Merton Council
Planning Applications Committee
26 April 2023
Supplementary agenda

Modifications Sheet.

ITEM 5 (WIM CHASE STATION, KINGSTON ROAD & 45 – 48 ROTHESAY AVENUE, RAYNES PARK, SW20 8JT)

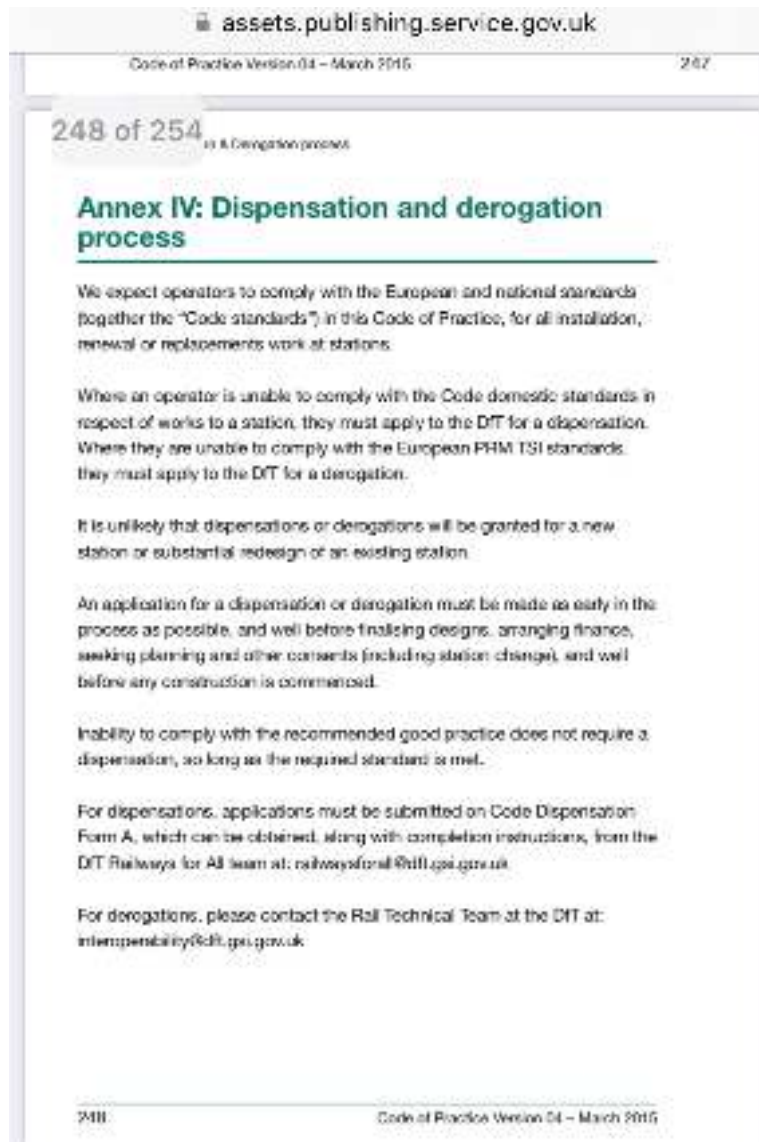
Para 7.2.8 in the report pack is a bit of a stretch. “Whilst step-free access is not proposed as part of this application, the proposal demonstrates how step-free access could be achieved”.

The four options in the feasibility study have been rejected by the railway companies and there has been no demonstrable investigation of the “safeguarded” 5th option.

I attach some photos of proposed tunnel location since there are none in any of the documents.

The proposed development does not purport to provide step free access. A method by which step free access could be provided is suitably safeguarded by the proposed development as the main passenger concourse would be adjacent to the location where the tunnel would be created whereas currently it is adjacent to back of house facilities. Therefore, the proposal would allow for future step free access. At such time that step free access is proposed then further applications may be required. However, this does not affect the planning merits of this application, which should be considered on the basis of not providing step free access, but allowing for it in the future.

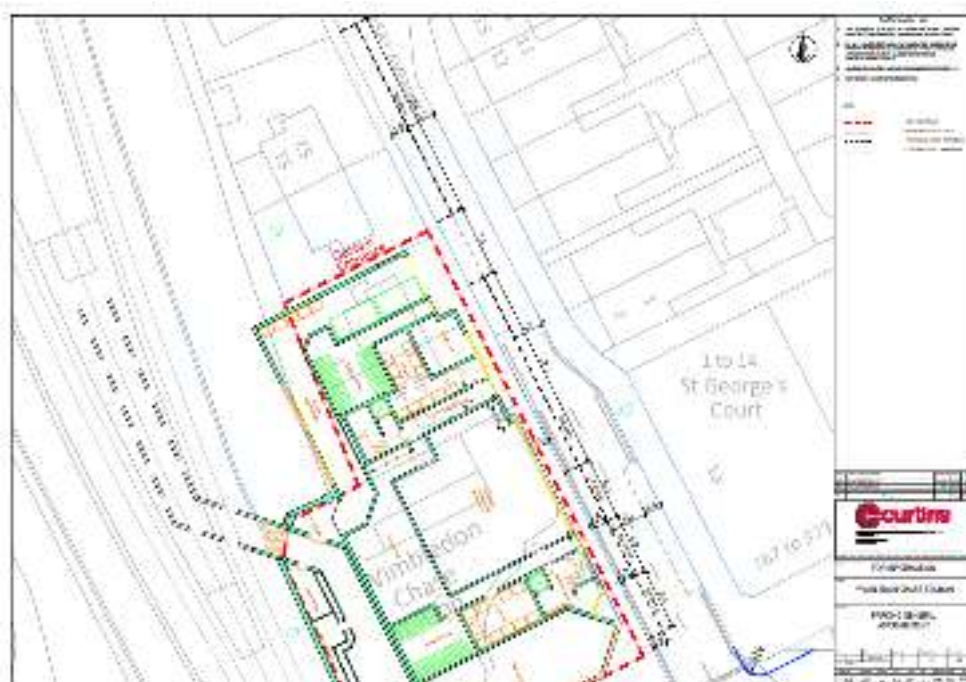
- With regards to the proposed loading bay on Kingston Road, it is proposed to introduce a buildout at the Rothesay Avenue/Kingston Road junction to mirror that at the Sandringham Avenue/Kingston Road junction.

- The proximity of the loading bay to the side road and the visibility for vehicles exiting the side road, would be exactly the same as the arrangement at Sandringham Avenue. The applicant has commissioned an independent Stage 1 Road Safety Audit for the proposed loading bay and no safety issues were raised with regards to the visibility for vehicles exiting Rothesay Avenue. Historical road accident data at the Sandringham Avenue/Kingston Road junction has also been interrogated and no significant correlations have been identified in the data that suggests the existing arrangement at Sandringham Avenue is unsafe.

- No evidence has been presented to demonstrate that existing arrangement at the Sandringham Avenue/Kingston Road junction is unsafe. We are also not aware any plans to change the existing arrangement.

- Servicing is currently permitted on Kingston Road to the west of Rothesay Avenue on the existing double yellow lines during certain times (10.00 until 16.00 and 19.00 to 07.00 Monday to Saturday and without a restriction on a Sunday). This will have an influence on visibility similar to the proposed formalised loading bay arrangement, arguably worse. In addition, there are no servicing restrictions along the double yellow lines on Rothesay Avenue.

- It is considered feasible that the proposed development could be serviced from the existing servicing bay on Kingston Road to the east of Rothesay Avenue. This is approximately 50m from the proposed development, however, the proposed retail unit is only small in size and could have the size of the servicing vehicle restricted by planning condition if required. This arrangement would result in an additional 17.6m of clear kerb line being available on Rothesay Avenue (including the removal of one disabled car parking space so that only two are provided). This could be increased further if the disabled car parking were to be dealt with by way of a financial contribution. This would keep the existing highways arrangement on Kingston Avenue.

The servicing requirements for the proposed units would be limited due to its modest size. The scheme would not result in the overall loss of any parking bays. If concerns remain in relation to the proposed loading bay it would be entirely feasible for the development to utilise the existing loading bay. This would allow for the retention of a further two on-street parking bays on Kingston Road.

Officers advise that a revised servicing plan could be secured by way of condition, to be discharged in conjunction with the Council's Transport Planner and Highway Authority, along with TfL if necessary.
